DESIGN ADVISORY BOARD Tuesday, August 22th, 2017 at 3:00 PM Conference Room 12, City Hall, Burlington, VT Agenda

1. 18-0059CA/CU; 308 Main St (RH, Ward 8E) 308 Main Street LLC

MEMORANDUM

To: The Design Advisory Board
From: Mary O'Neil, AICP, Principal Planner
RE: ZP18-0059CA/CU 308 Main Street
Date: August 22, 2017 Continued review

sheet title:
PROPOSED
ELEVATIONS

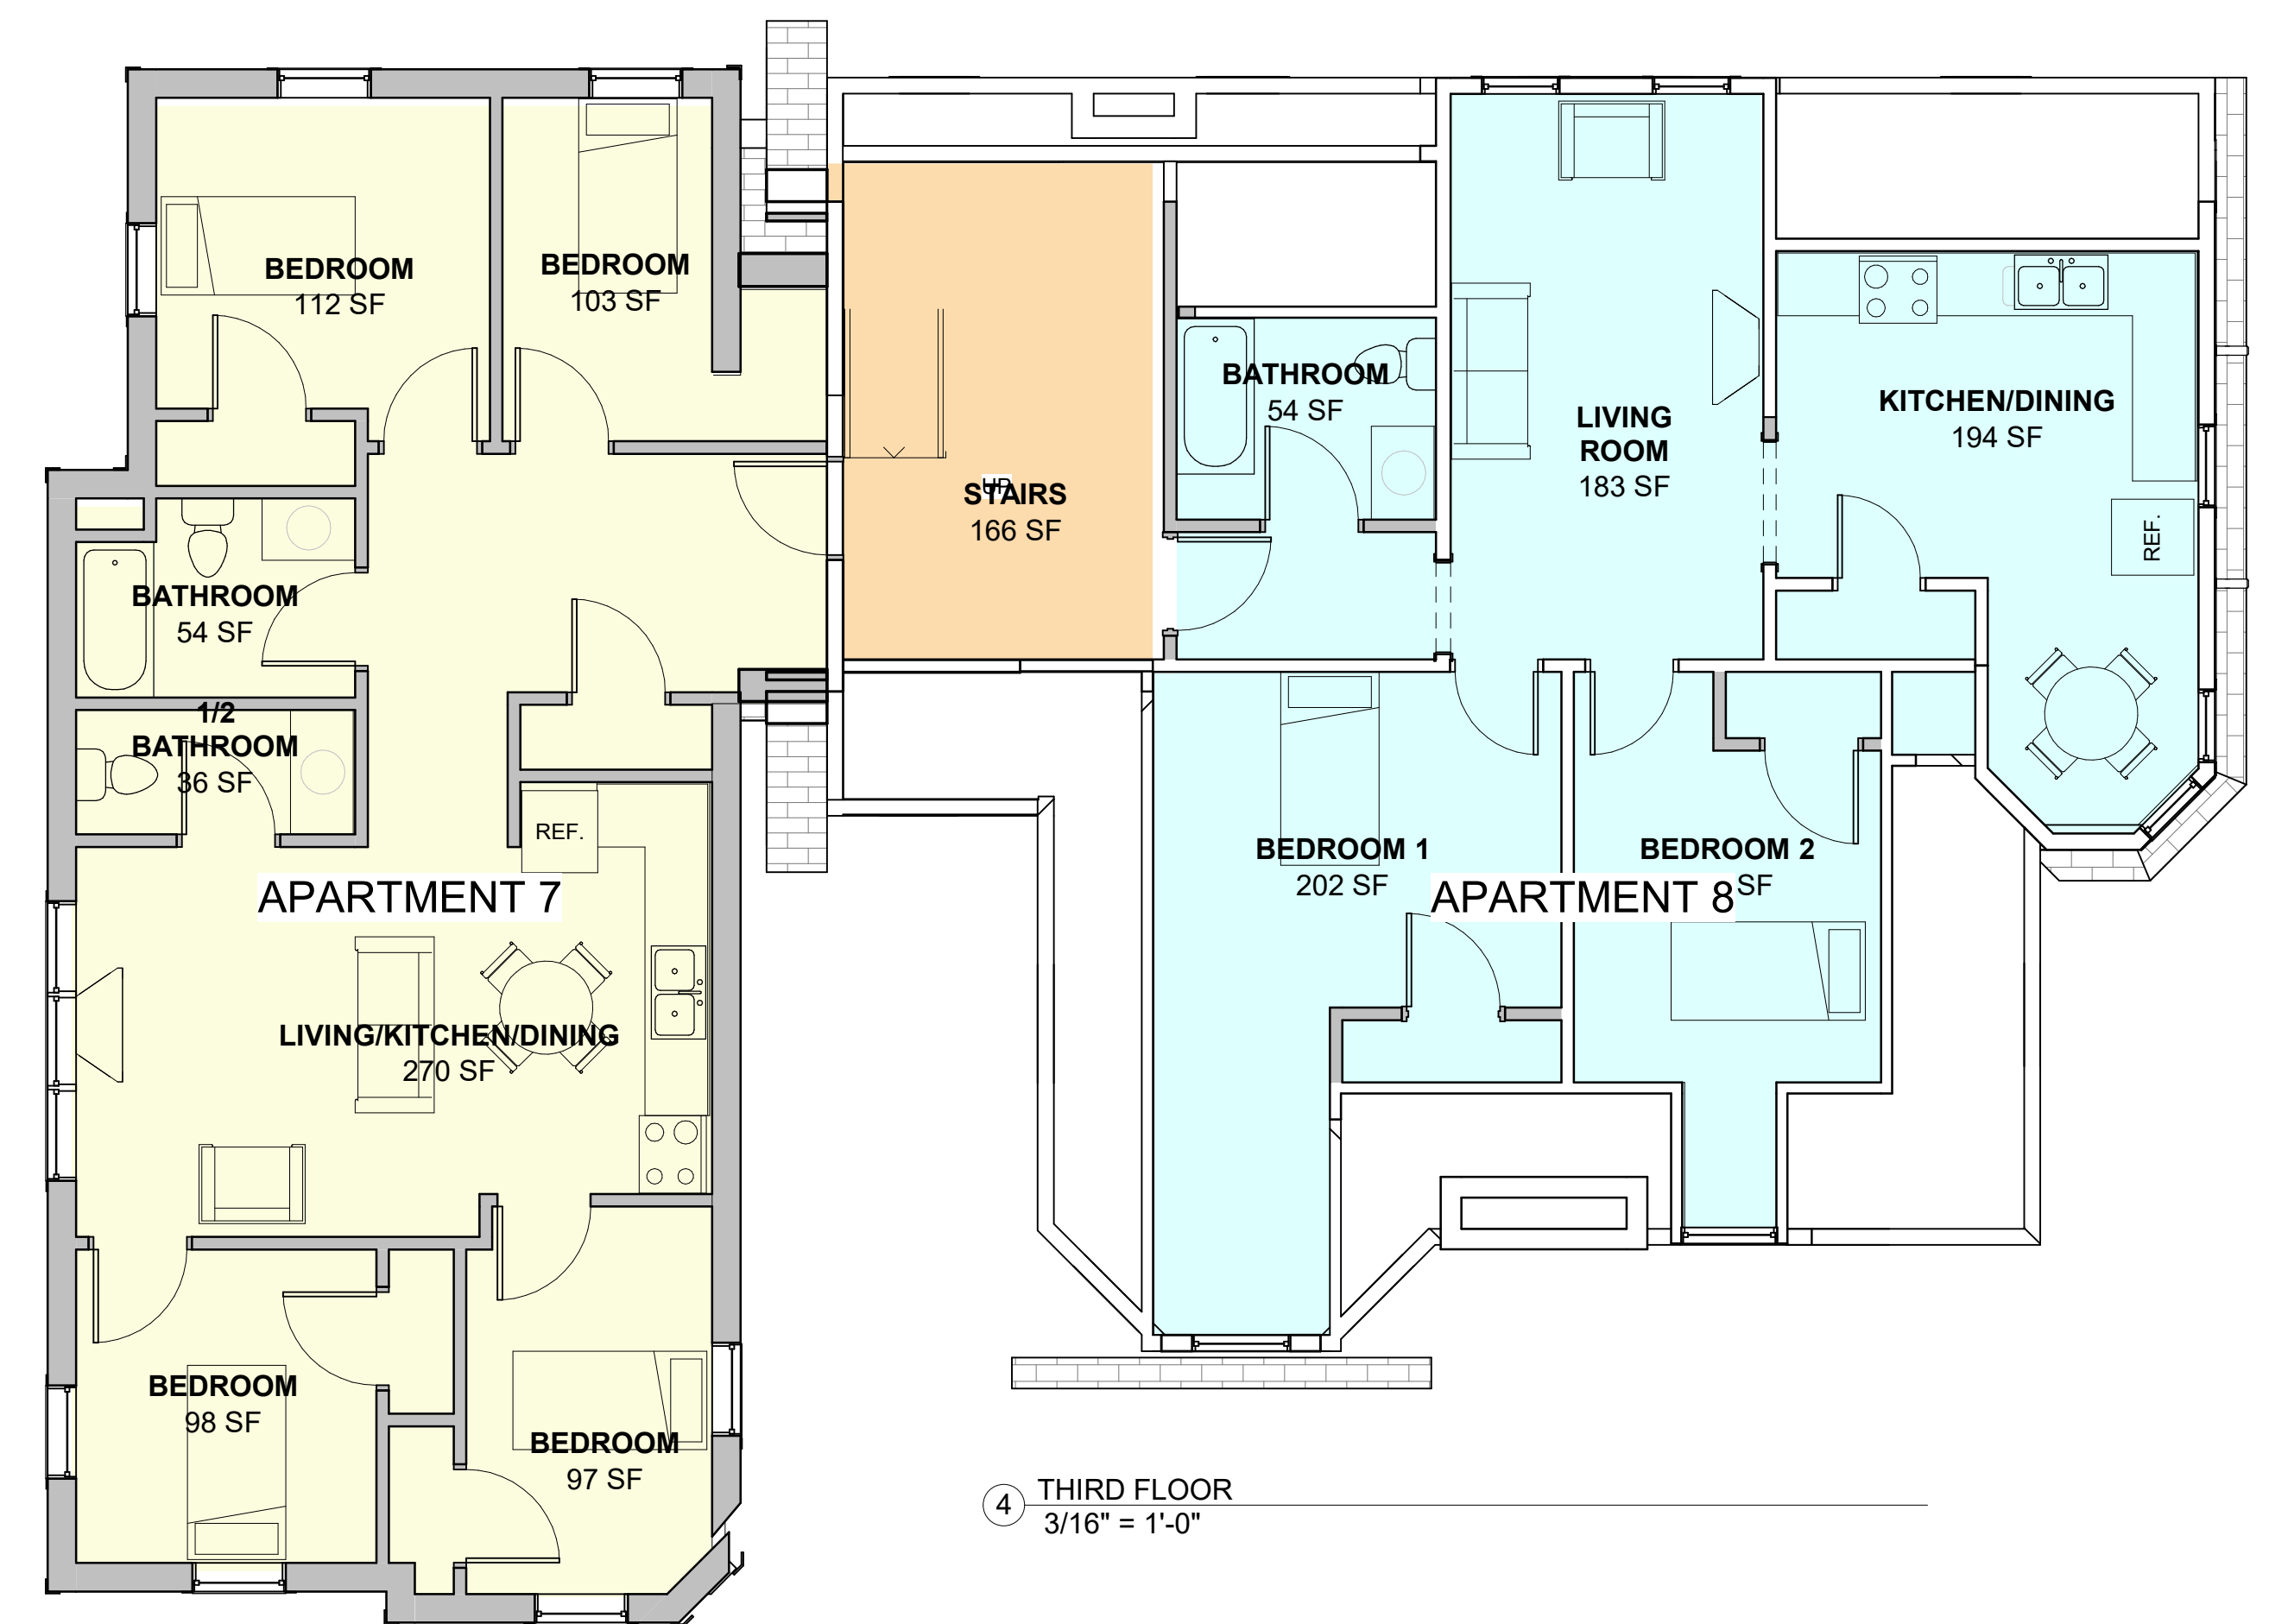
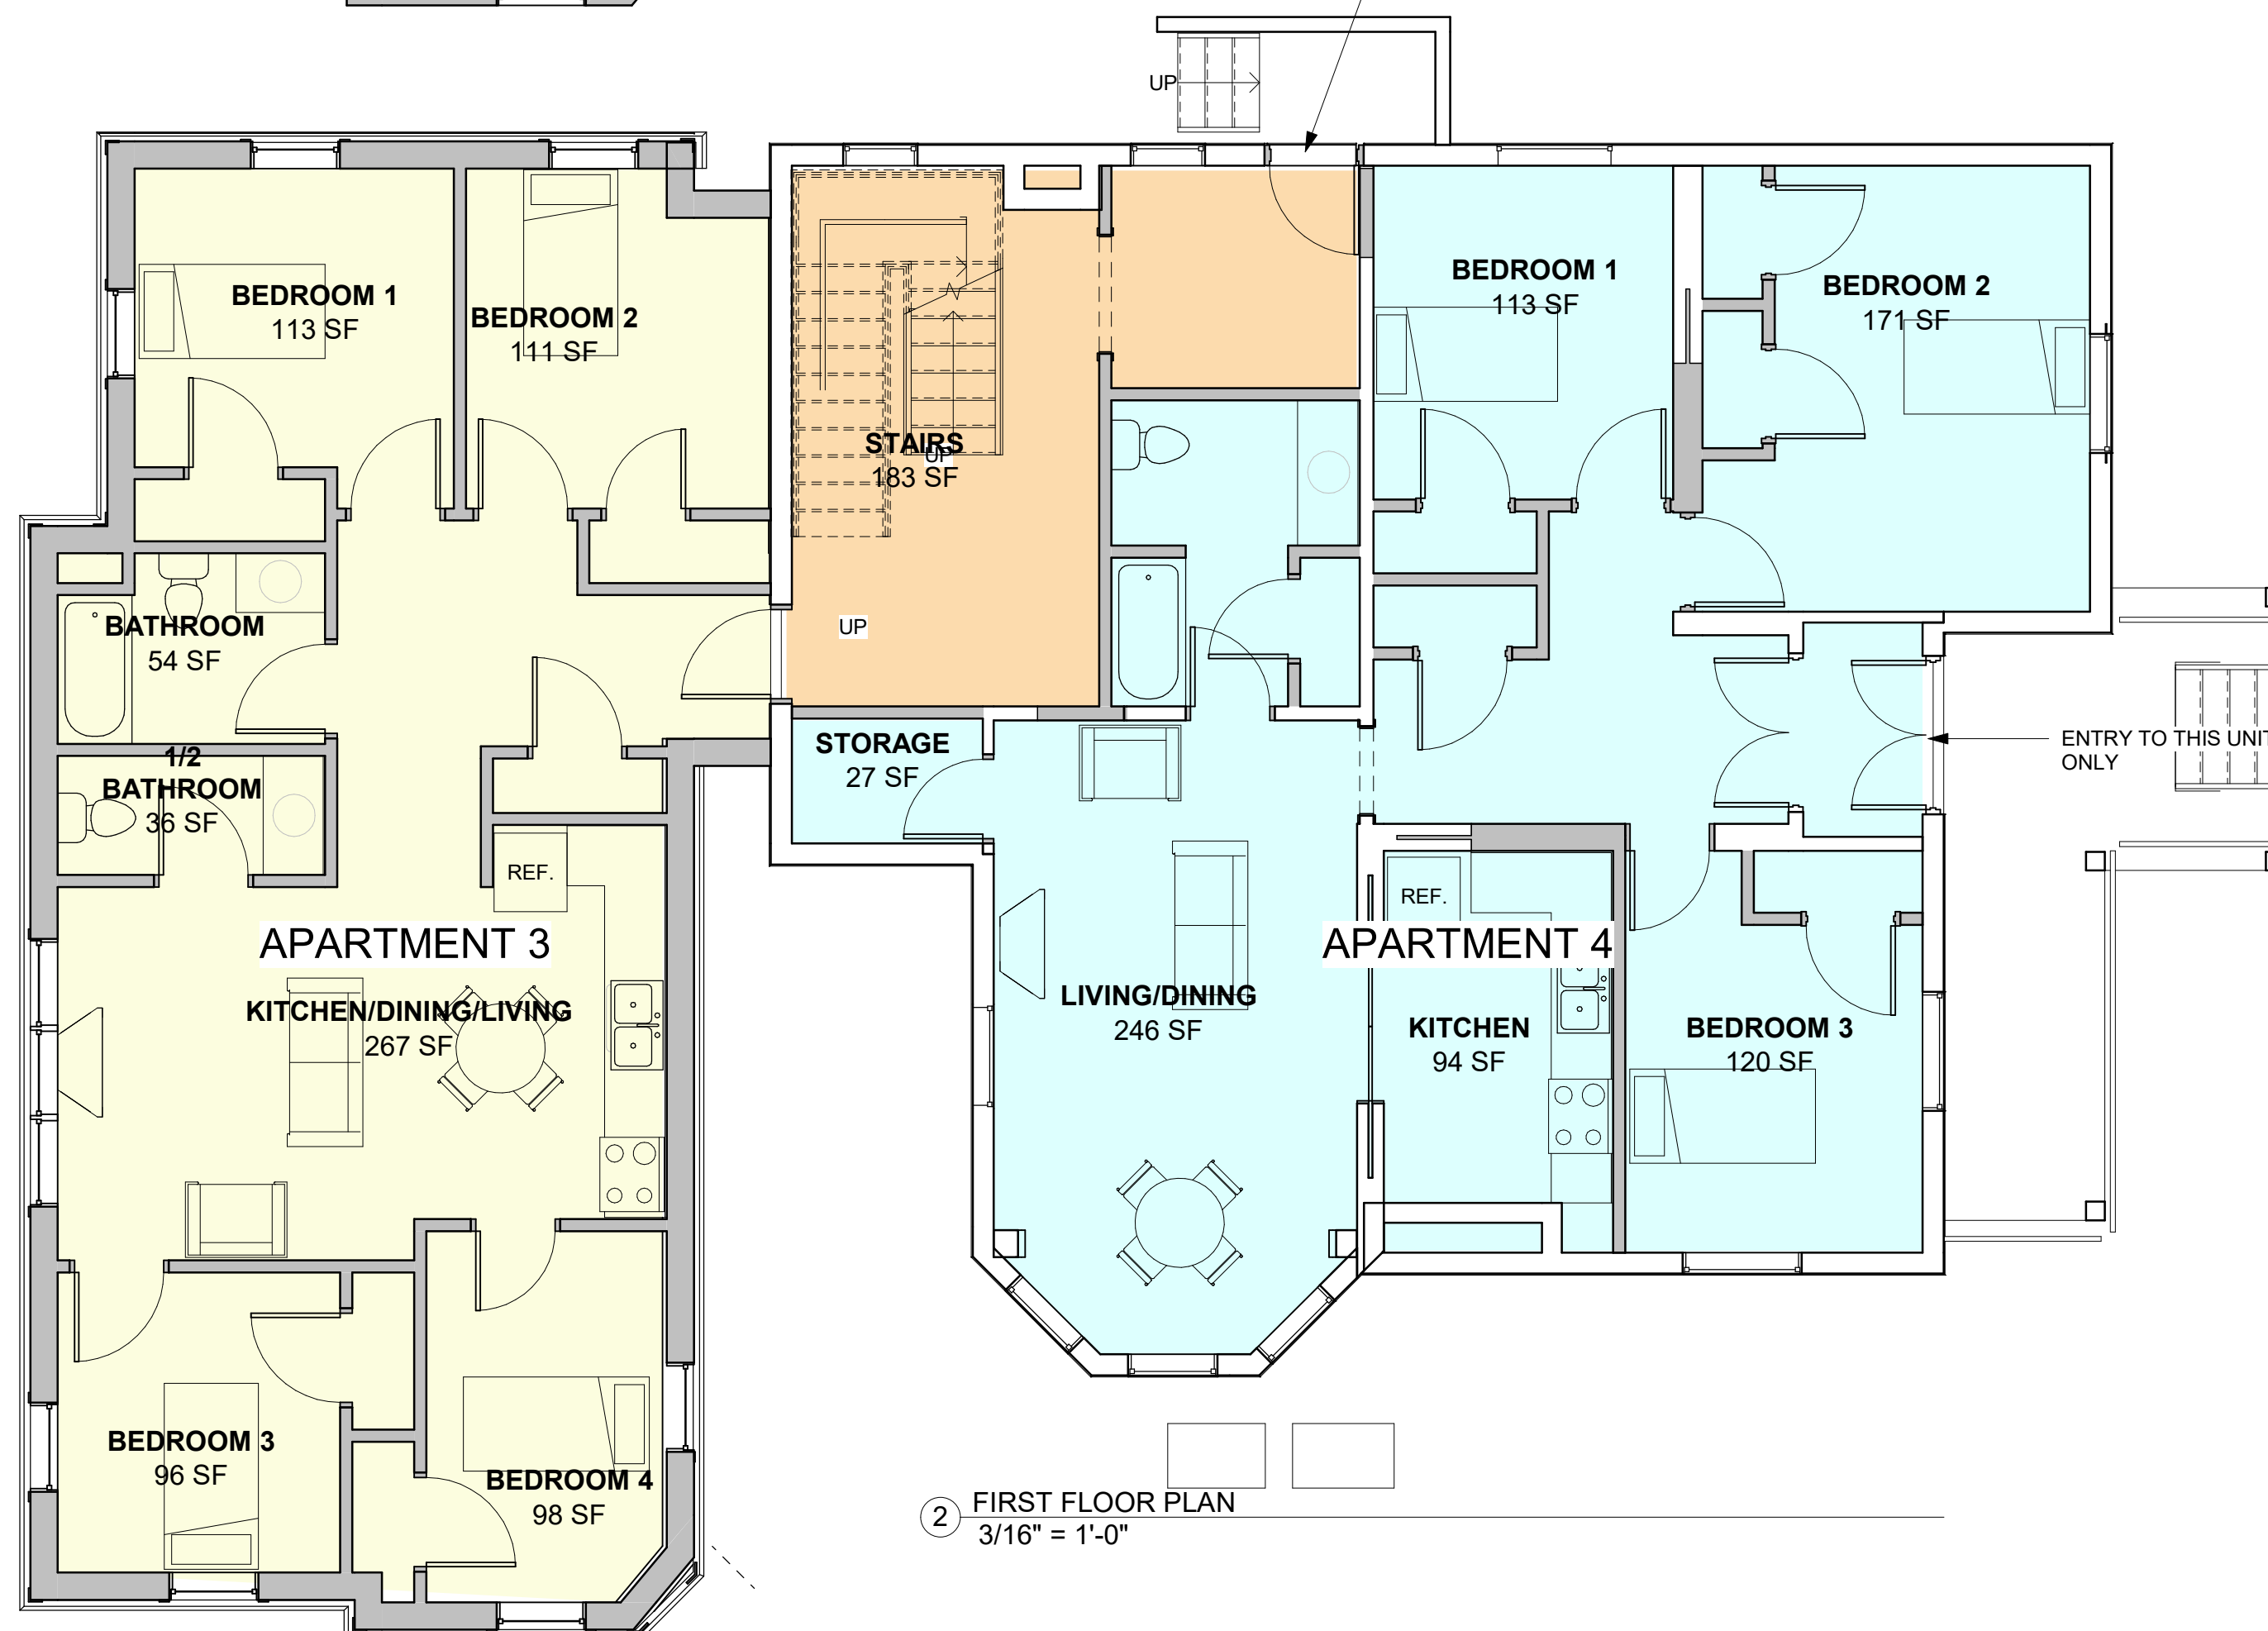
The proposal for a 3 ½ story flat roofed addition is quite contrary to the existing building and most within the streetscape. Submitted photos draw a parallel to the adjoining Captain Dan Lyons' house (1856); adjacent on the lot to the west. That structure precedes the Fisher House by more than a score of years. The principal structure has a low pitched hip roof with boxed cornice and broad projecting eaves, not a flat roof. It differs stylistically (early Italianate – and anecdotally originally had a roof lantern) and in massing (major structure with derivative rear ell); quite different from what is proposed at the back of 308 Main Street.

The scale proposed for the new addition is quite strident, given the sensitivity of the existing building and the proposed disparate architectural style. The addition is clearly visible from the streetscape (west, south and north) and generates conflict in proximity and appropriate scale to the Fisher House.

Although the applicant cites a neighboring building with a flat roof as support for this design, the addition bears no relationship to the existing historic structure. The sharp delineation of the roof form is quite contrary to the complex organization of the existing house; the differences abrupt and unsettling.

Direction given by the DAB's motion 8.8.2017 to create more pronounced articulation/ physical separation between the two masses, especially at the third floor roof line have spurred revised plans with a connector that slightly pushes the addition north, providing a pitched roof at the third floor between building masses.

The addition presents horizontal continuity of window bands. The windows themselves show no relationship to the existing building other than their arrangement so as to suggest floorlevels.

1. Applicant to make revision to reduce perceived scale relative to existing building by minimizing cornice at the top of the 3rd floor;
2. Eliminate panels to reduce verticality on east and west sides;
3. Material texture and color of 3rd floor be different;
4. Joint between building masses be different from primary cladding.
